**SUBJECT: El Segundo Power Redevelopment Project (00-AFC-14C)  
Revised Staff Analysis of the Proposed Change to Dry Cooling and  
Other Project Changes**

# EL SEGUNDO POWER REDEVELOPMENT PROJECT

## Revised Staff Analysis

JUNE 2010  
CEC-700-2008-006-REV1

**PROJECT DESCRIPTION - SITE PLAN - FIGURE 2**  
 El Segundo Power Redevelopment Project - Amendment Petition For Dry Cooling

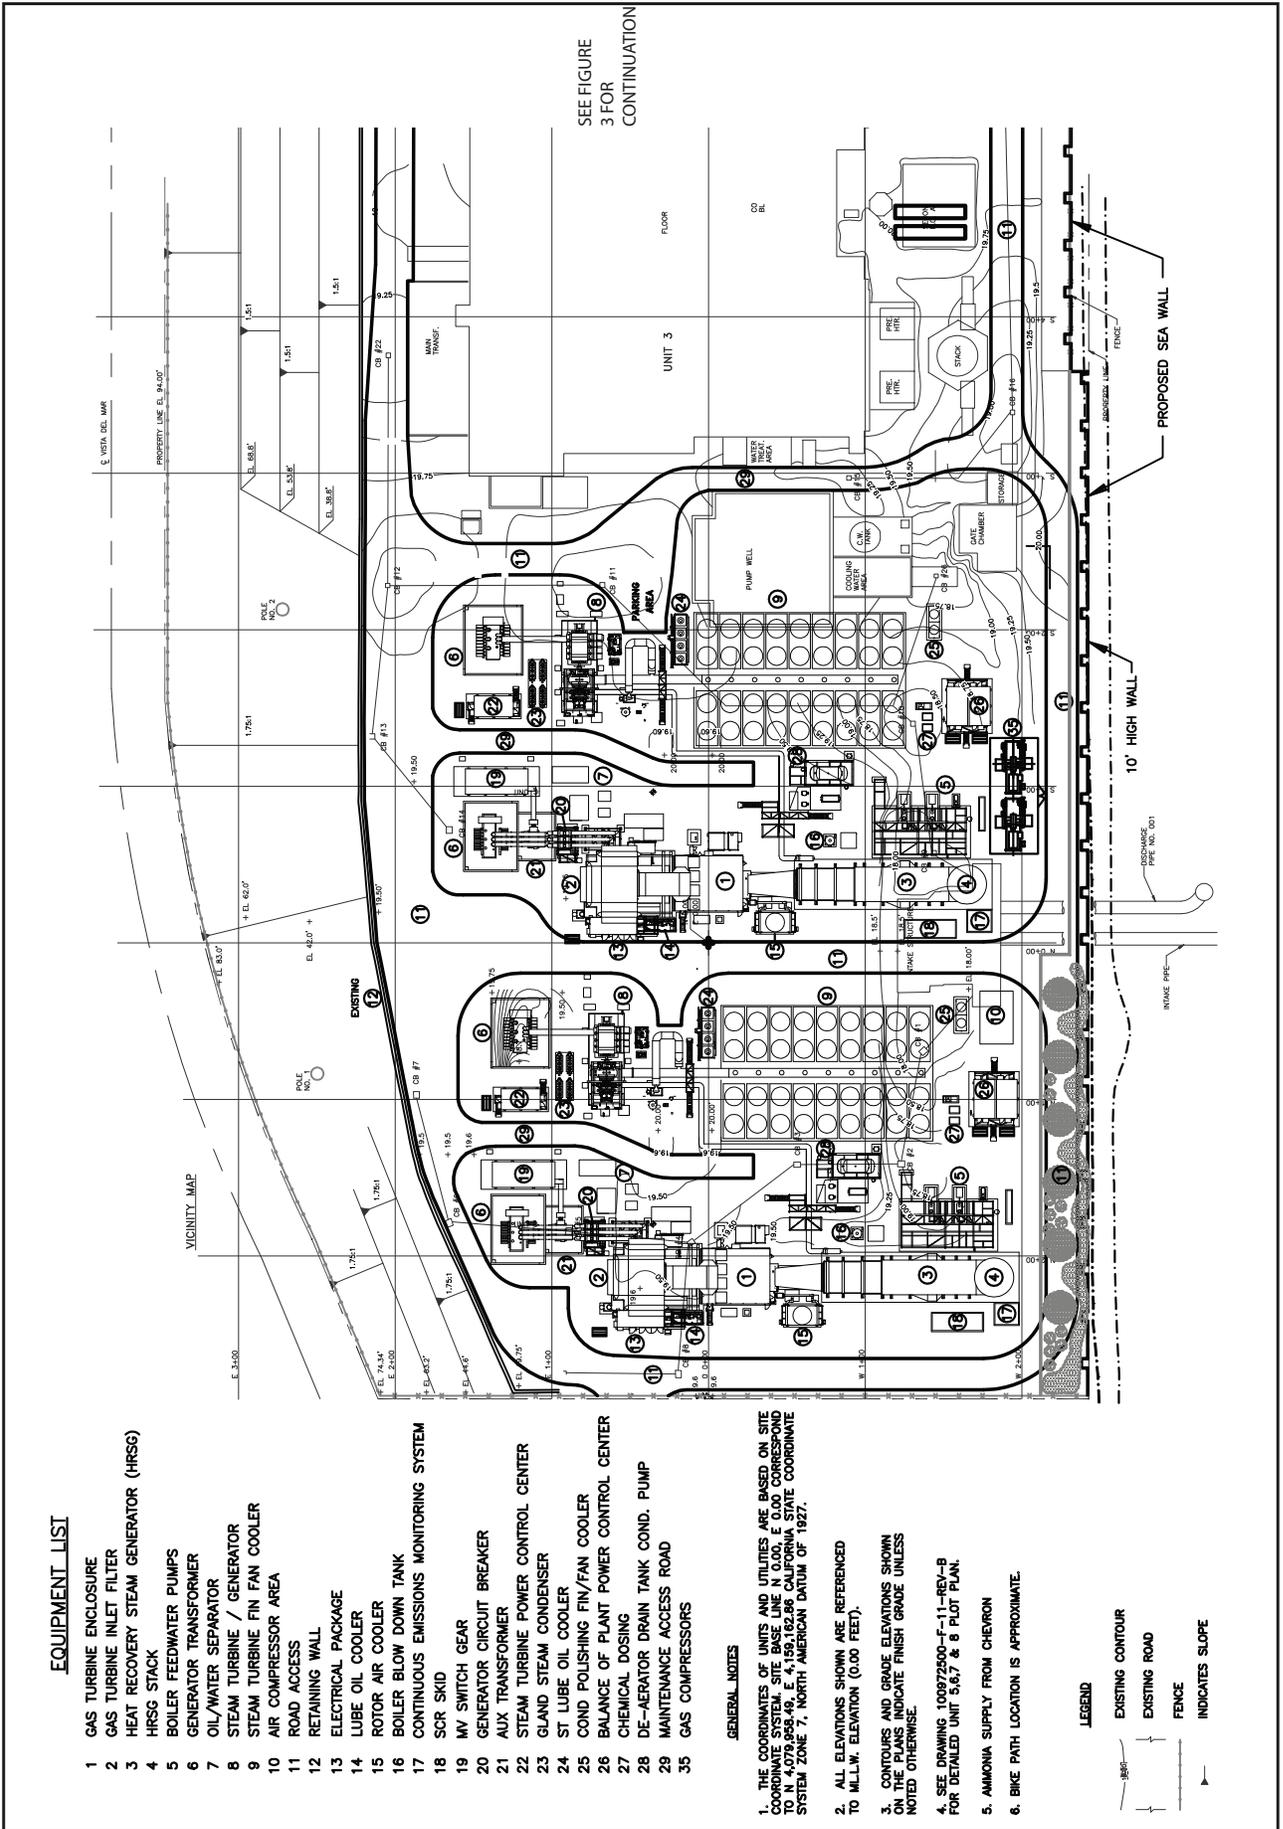
The site plan on **PROJECT DESCRIPTION Figure 2** illustrates the location and size of the proposed generating facility presented in this amendment petition. For comparison, the overall layout of the new facility will be located in the same general area of the facility as previously permitted. The primary changes to the site plan include the following:

- Addition of two air cooled heat exchangers for cycle heat rejection;
- Use of single pressure, single-pass HRSGs instead of three pressure, vertically oriented drum HRSGs;
- Movement of the northern end of the facility seawall to the west to accommodate the slightly larger footprint of the rapid response – combined cycle technology;
- Modification of the plant entrance road including widening and straightening; and
- Location of water storage tanks on the south side of existing units 3 and 4.

The arrangement of two 1x1x1 power blocks occupies a slightly larger footprint than the previously permitted project. Since the two power blocks can operate independently and include more equipment than a 2x2x1 configuration, an access road has been added between the power blocks. Access roads around dimensions and turning radii have been reviewed with the El Segundo Fire Department for compliance with local codes.

**LAND USE - FIGURE 5**

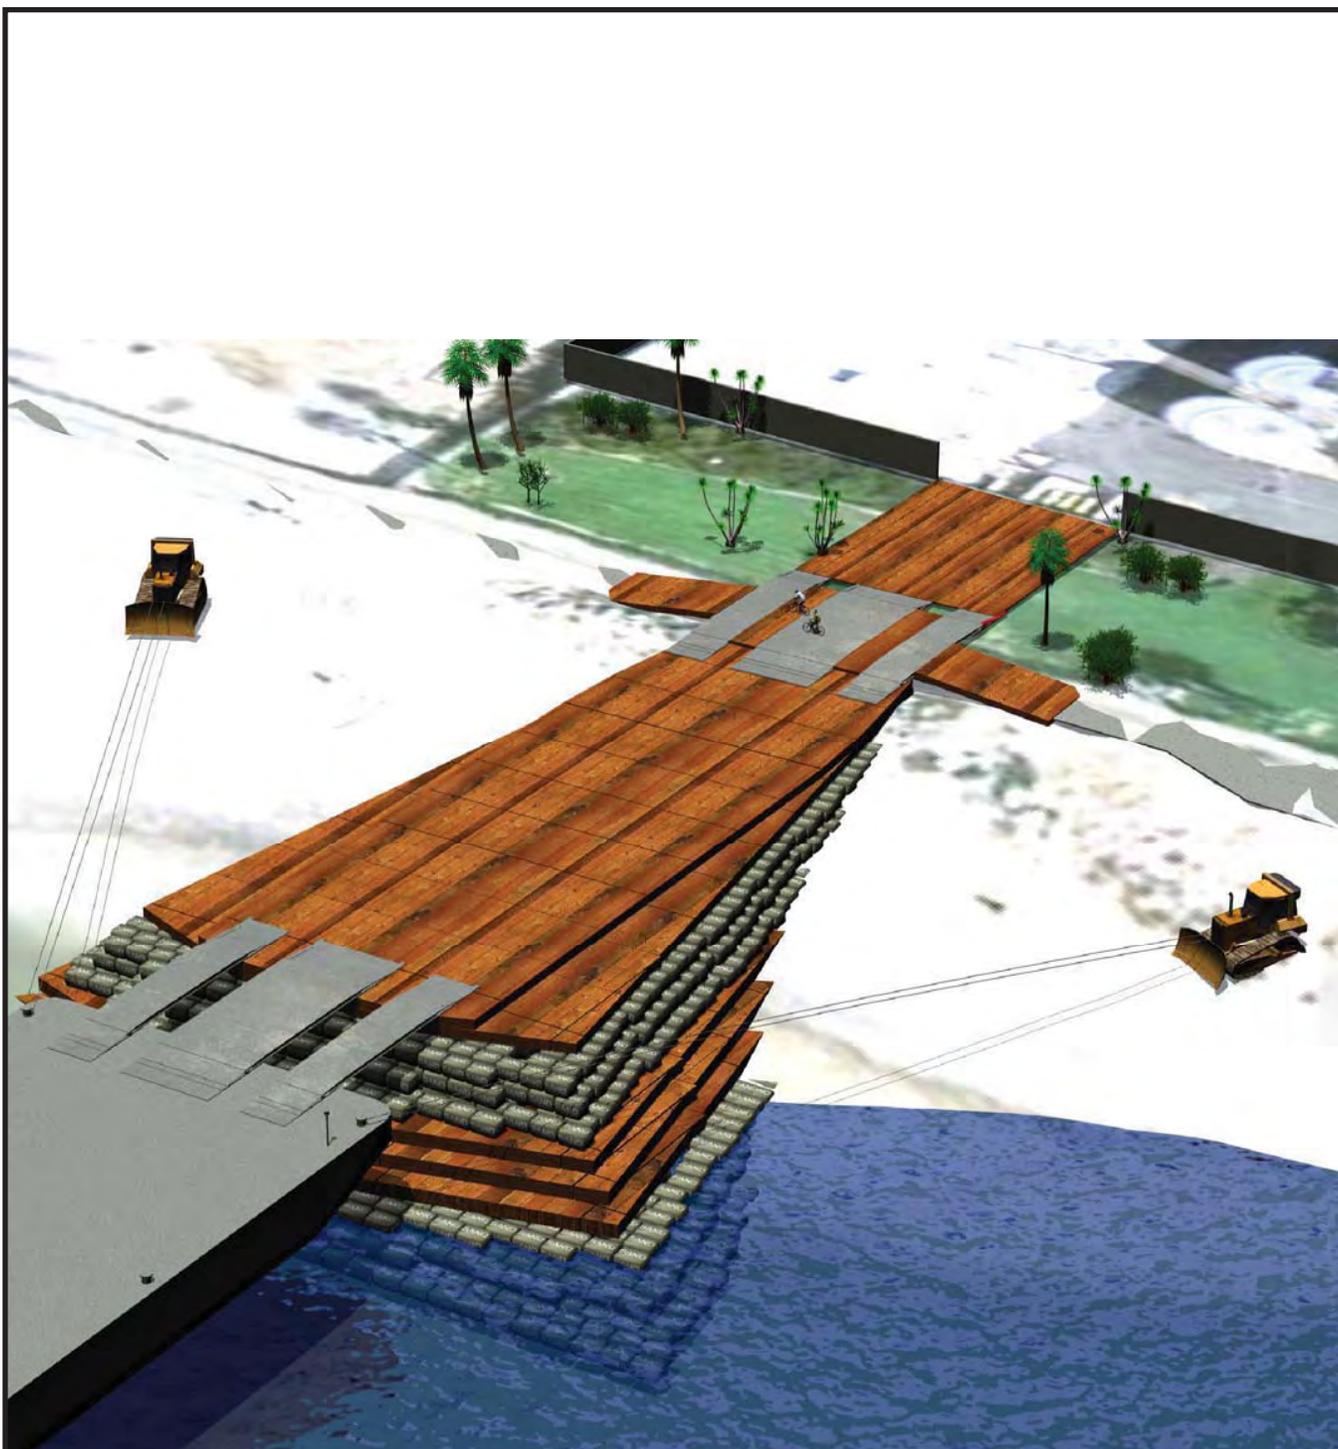
During the beach delivery phase, beach users would not be able to use an approximate 300-foot by 300-foot (2 acres) beach area west of the ESGS between Dockweiler State Beach and Manhattan Beach (**LAND USE Figure 3** – Beach Area West of the ESGS). This beach area, owned by the project owner, is to be traversed by an approximate 250-foot long beach ramp made of geo-tech fiber, wood matting and sandbags with an access ramp extending over the bicycle trail into the ESGS. The access ramp would include closure gates across the bike path to prevent public access to the beach ramp during deliveries. Fencing for safety and security purposes would be installed around the beach delivery area (**LAND USE Figure 4** – Conceptual Layout of Beach Delivery Area). The project's proposed ramp crossing the beach to move oversized equipment from barges docked in Santa Monica Bay to the project site may affect beach operations conducted by the LACDBH (Land Use Figure 5 – Beach Ramp Rendering).

**VISUAL RESOURCES - FIGURE 3**  
El Segundo Power Redevelopment Project - Final View KOP 2

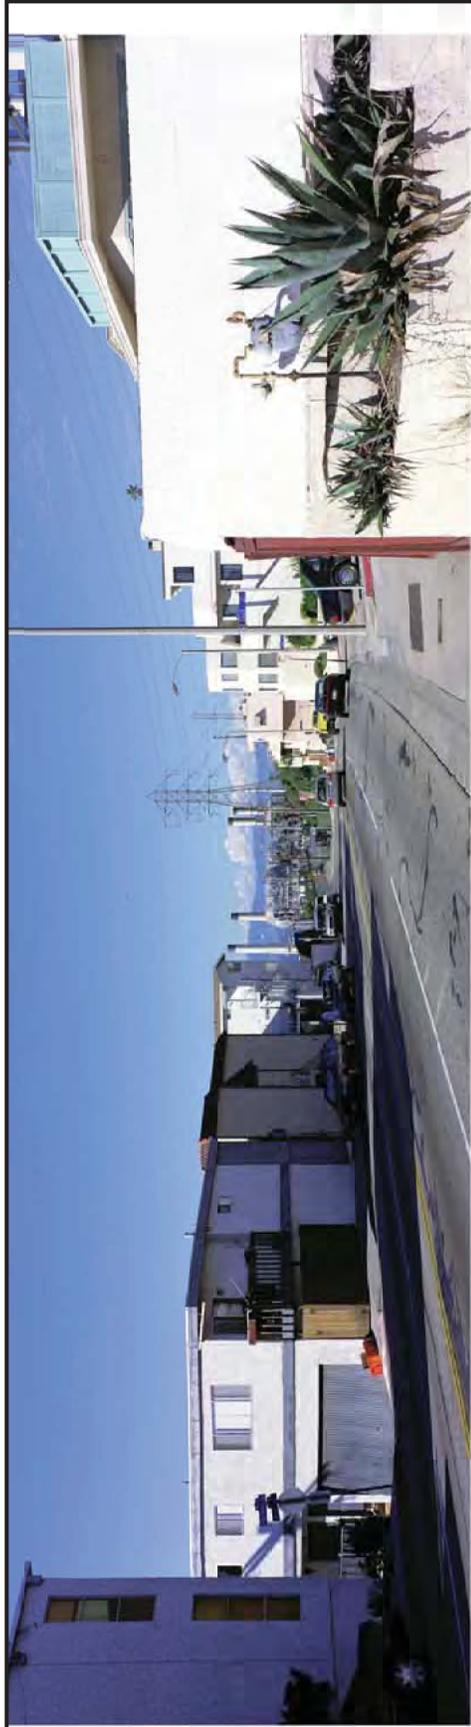
Visual quality from the area of this KOP, as seen in **VISUAL RESOURCES Figure 3**, is high due to panoramic Bay views in three directions. The ESPRP Units 1 and 2 power block is hidden behind Units 3 and 4, revealing only the visually subordinate exhaust stacks, which are closely aligned with the existing stacks.
